Product Information

Phase out OO FSK Mat. 485433 u. 485439

Roto AL

Universal hardware for aluminium windows and balcony doors

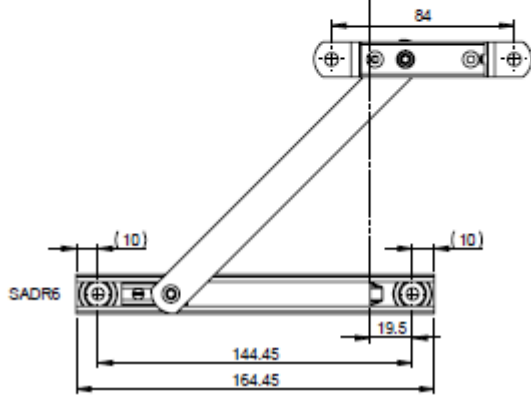
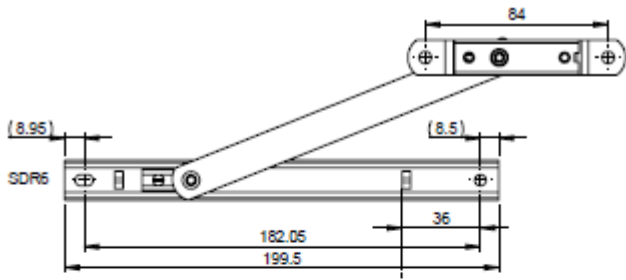
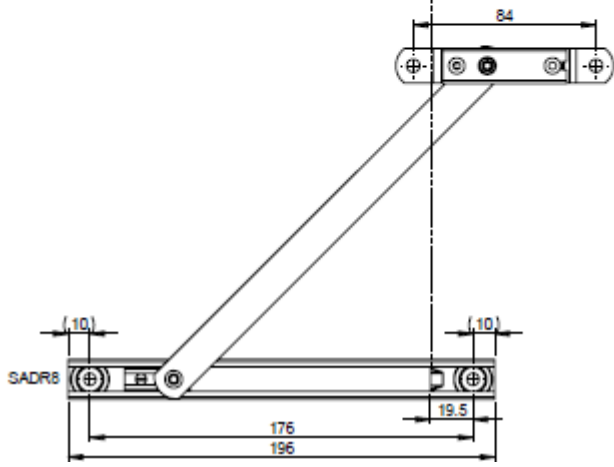
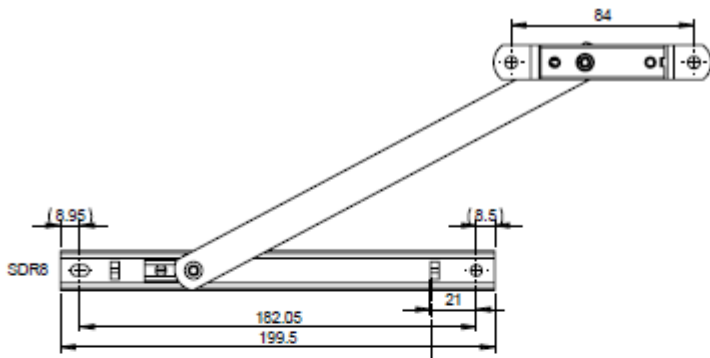
The supplier has changed the counterbores of the mounting holes; therefore the articles listed below will be removed from the program. Due to this change in hole geometry, the hole spacing / dimensions for sash mounting (C-rail) have also changed accordingly. The drawings have been made adjustments. Nothing has changed in terms of handling. The replacement can be used without restrictions. Phase-out date: with immediate effect or until remaining stocks are used up Spare parts: are not intended Return deliveries are not possible. Update 22.08.2024 Description has been adjusted and drawings have been added.

Article Code	Phase-out date	Target WüMatSt	Comments
485433 OO FSK RD TS 06 1 S 16 23 AU 9999	Apr 22, 2024	81	replacement 2039811
485439 OO FSK RD TS 08 1 S 16 23 AU 9999	Apr 22, 2024	81	replacement 2039812
